ADDENDUM NO. 1

State Project No. AIR 196-092A-1

GENERAL AVIATION RAMP EXTENSION

AUGUST 5, 2019

AIR 196-092A-1
Sheet 19 of 34
Drawing: C-1301
VOL. 1 of 1

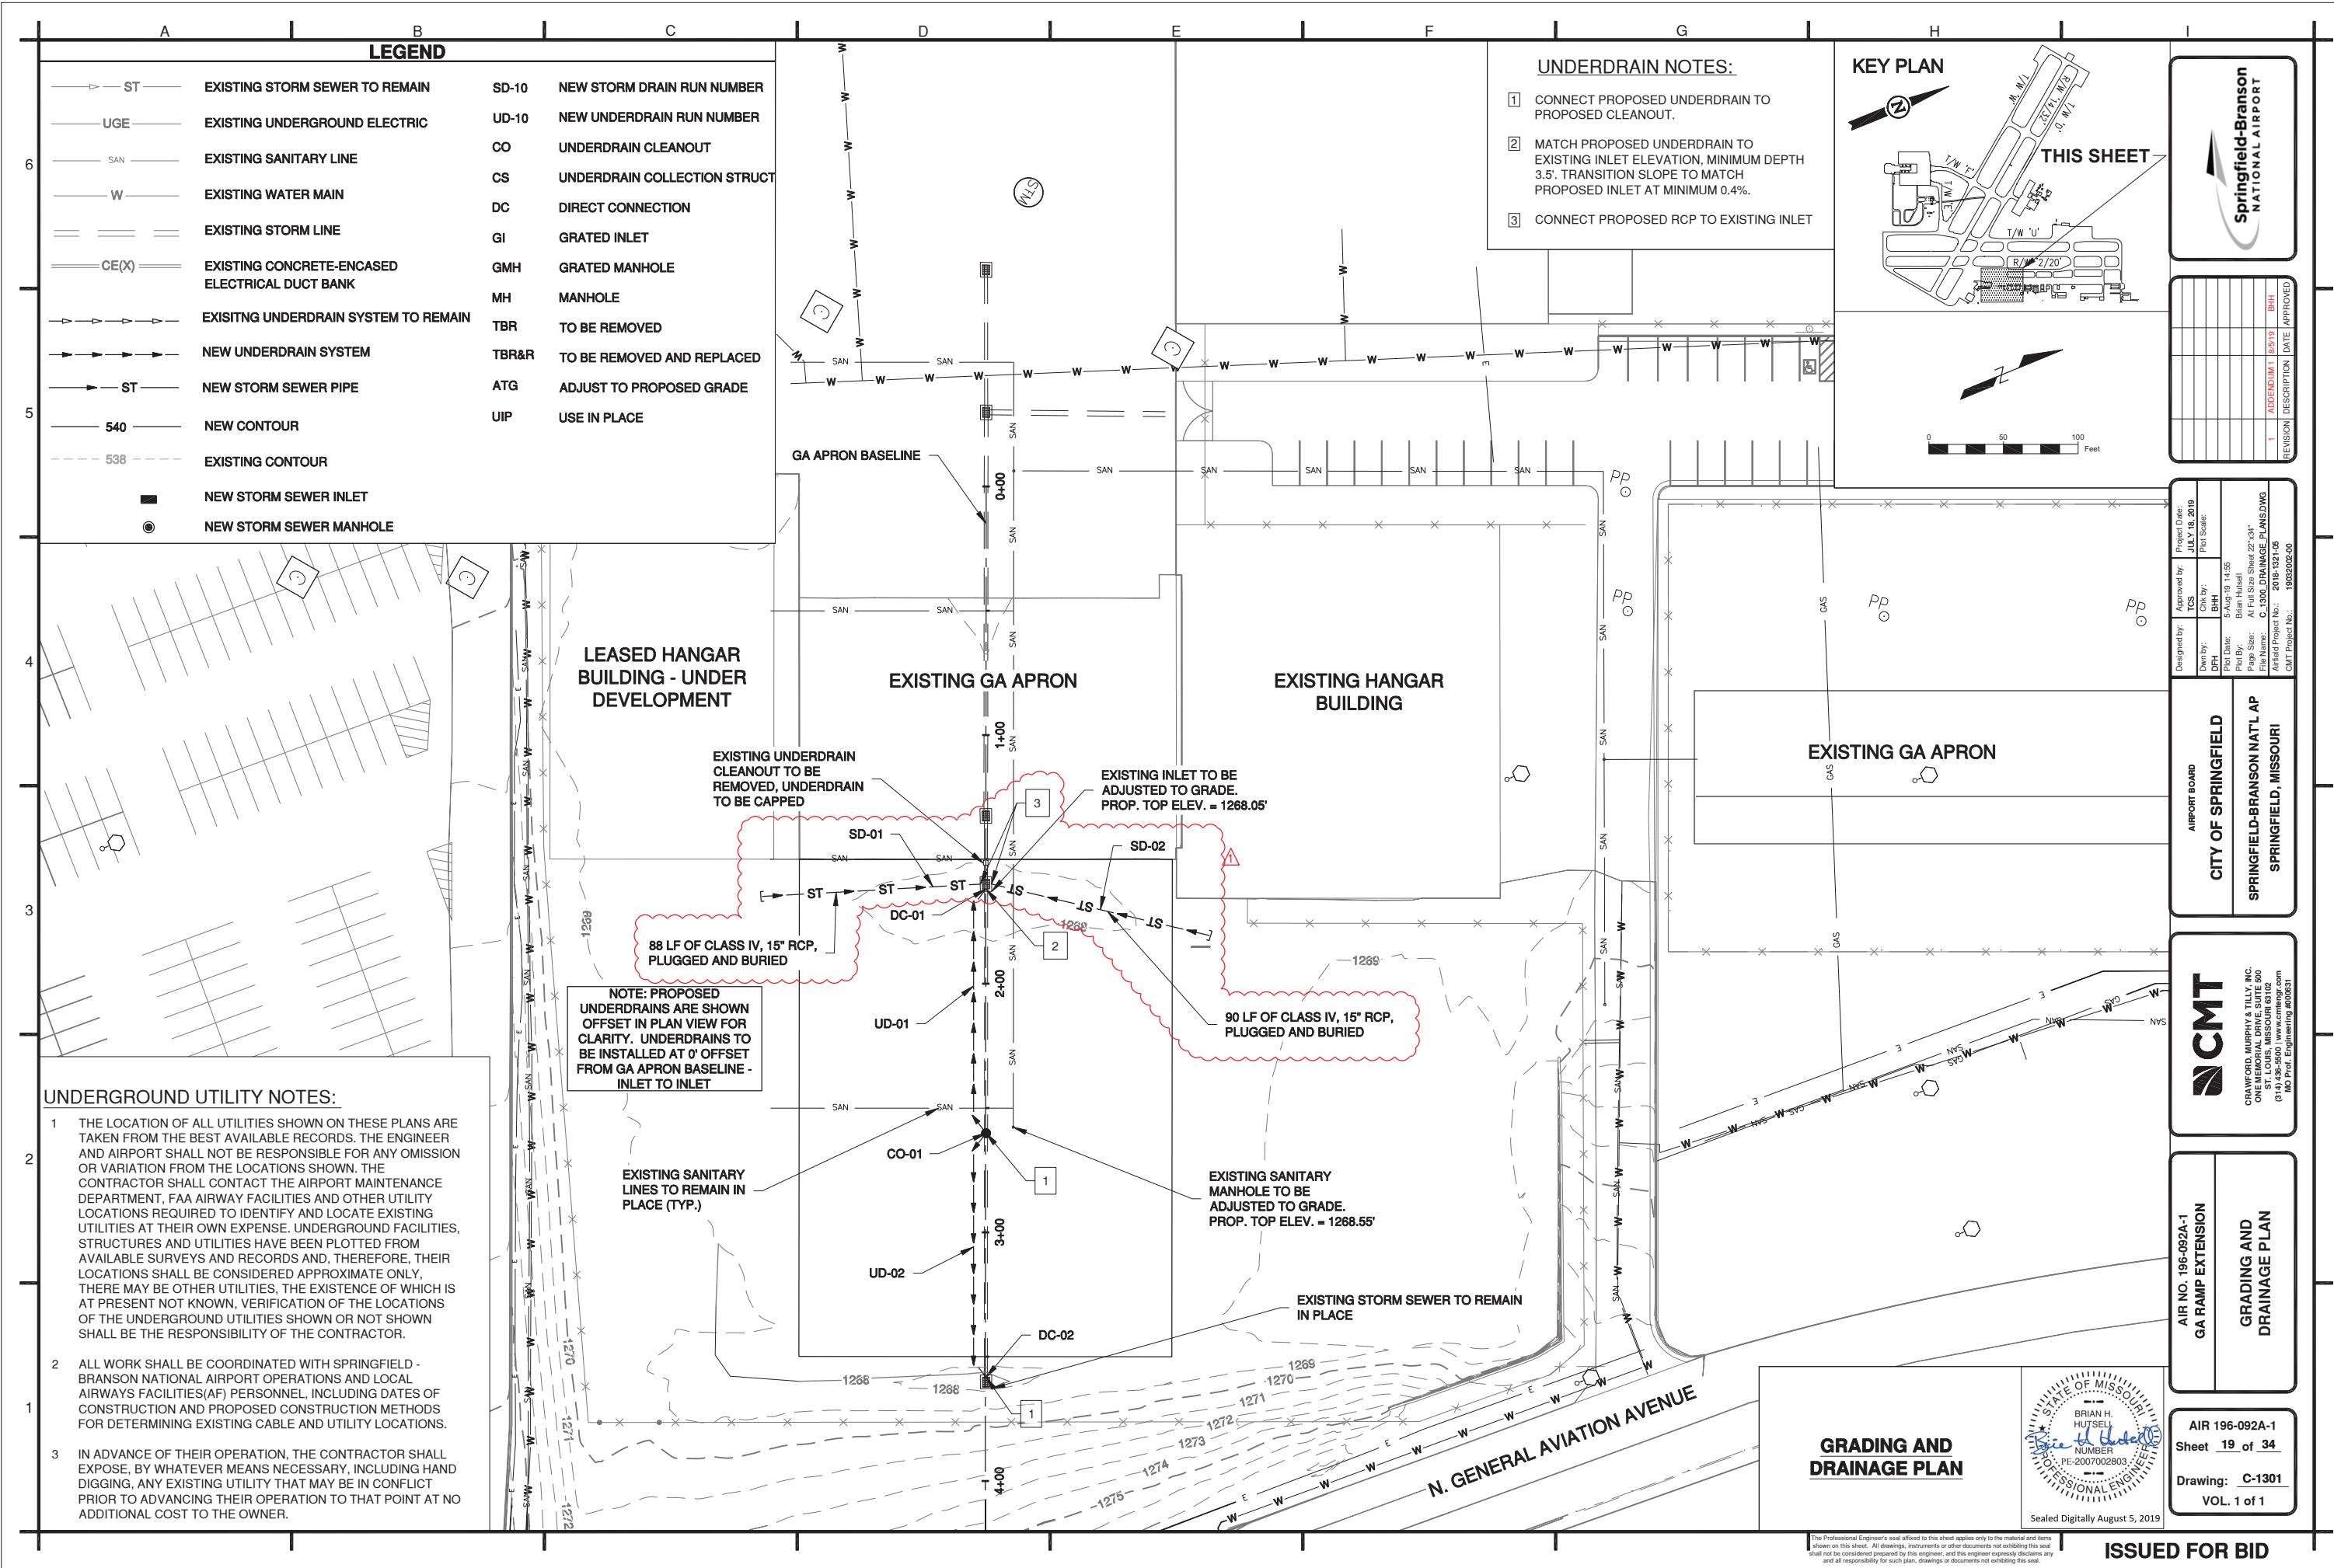
Sheet 19 of 34, GRADING AND DRAINAGE PLAN

DELETE: This sheet.

ADD: Attached sheet.

CLARIFICATION: Pipe stubs added for ease of connection for future hangar construction to north and south.

AIR 196-092A-1 Sheet 29 of 34 Drawing: C-5003 VOL. 1 of 1
--

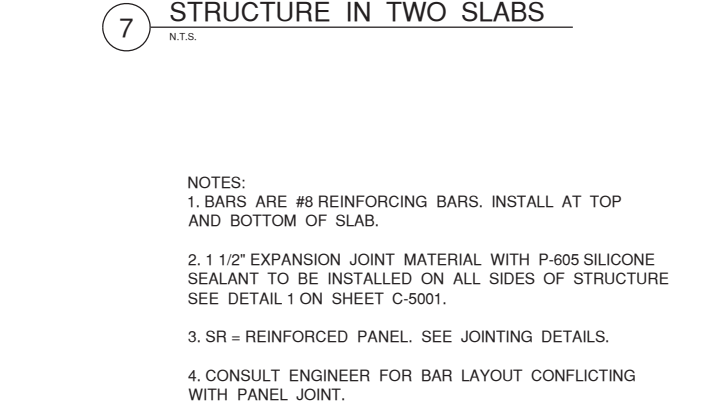
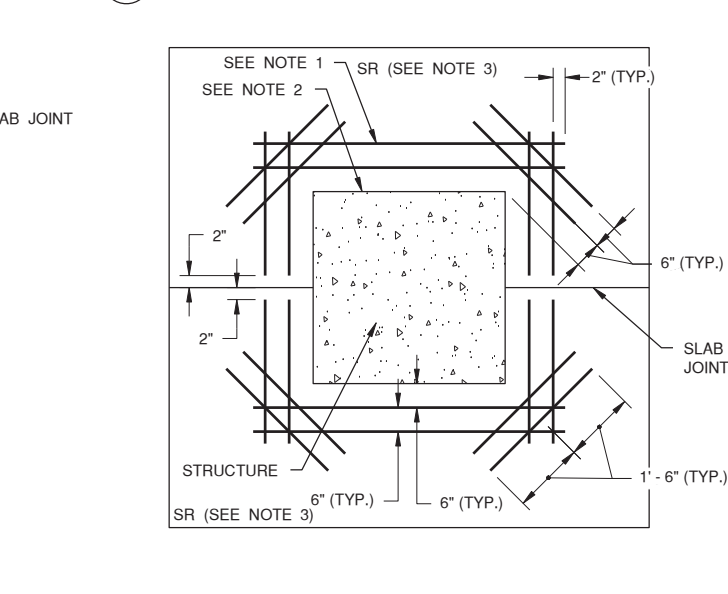
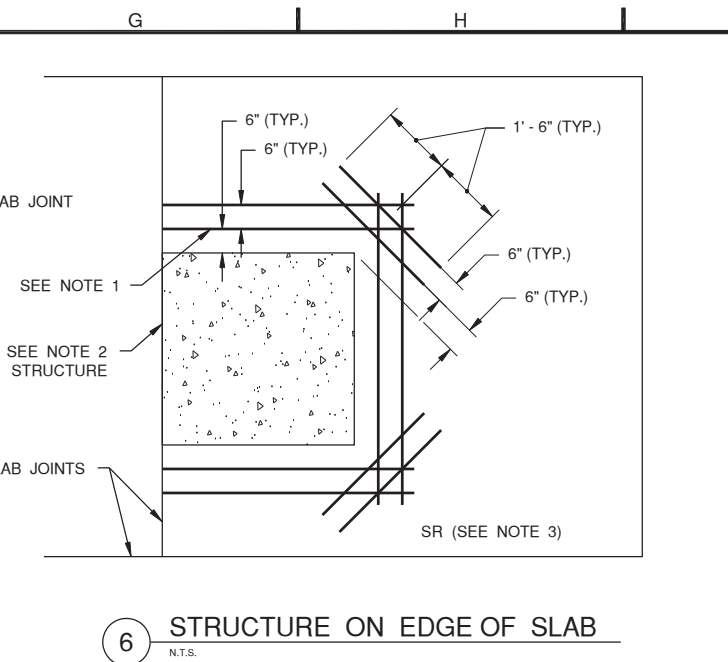
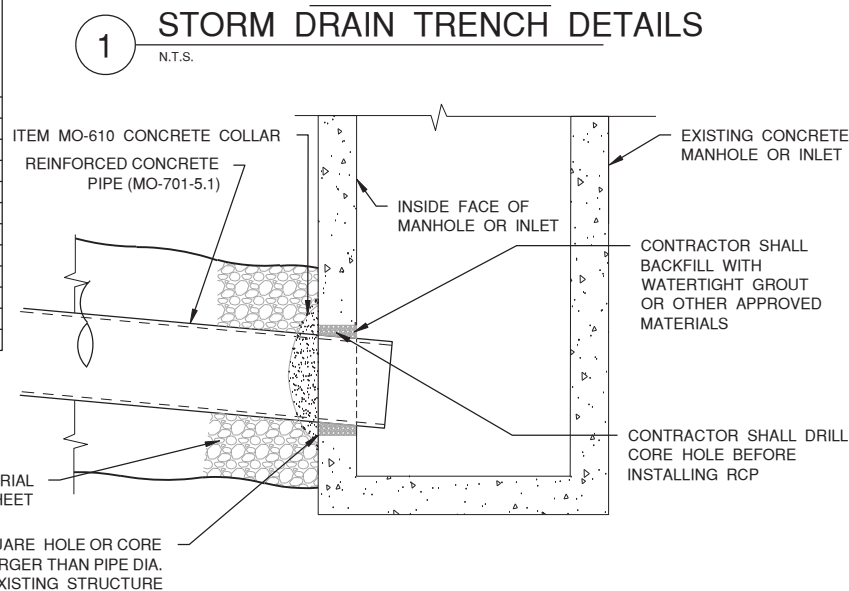
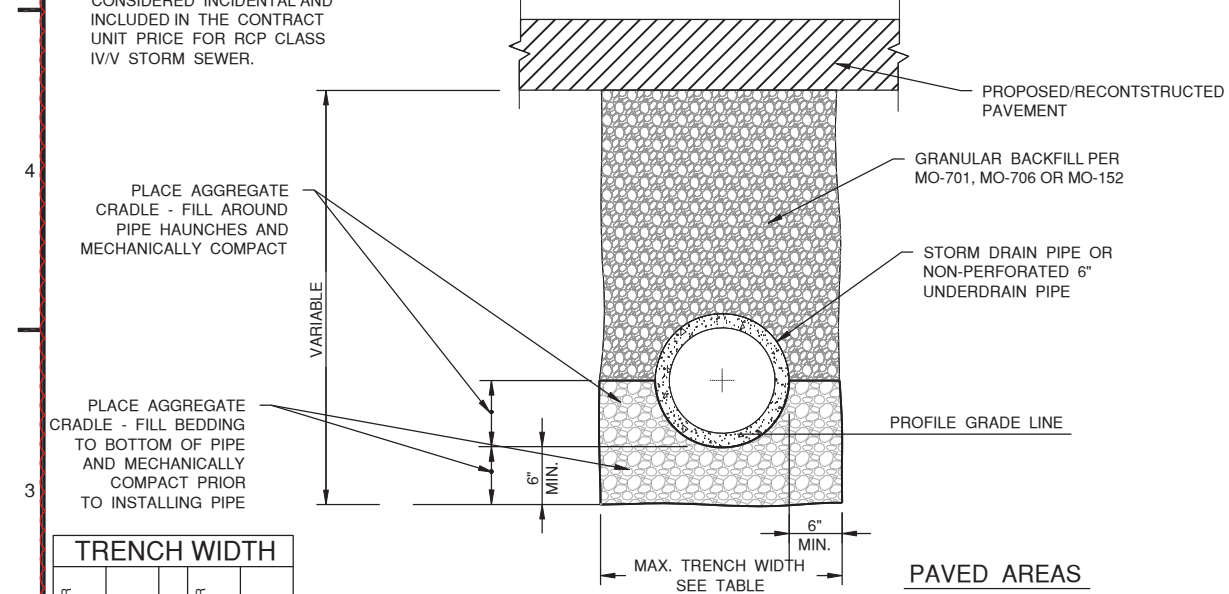
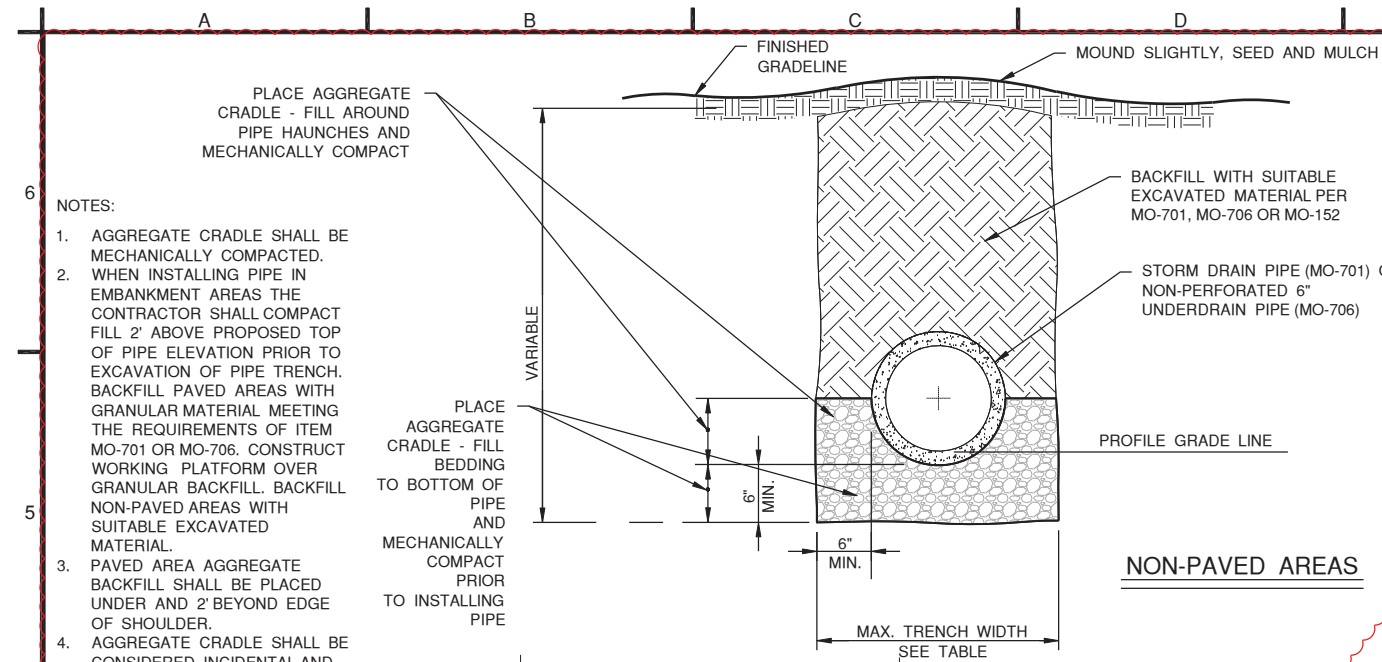
Sheet 29 of 34, GENERAL DETAILS SHEET 3

DELETE: This sheet.

ADD: Attached sheet.

CLARIFICATION: Details for pipe stubs added on sheet 19
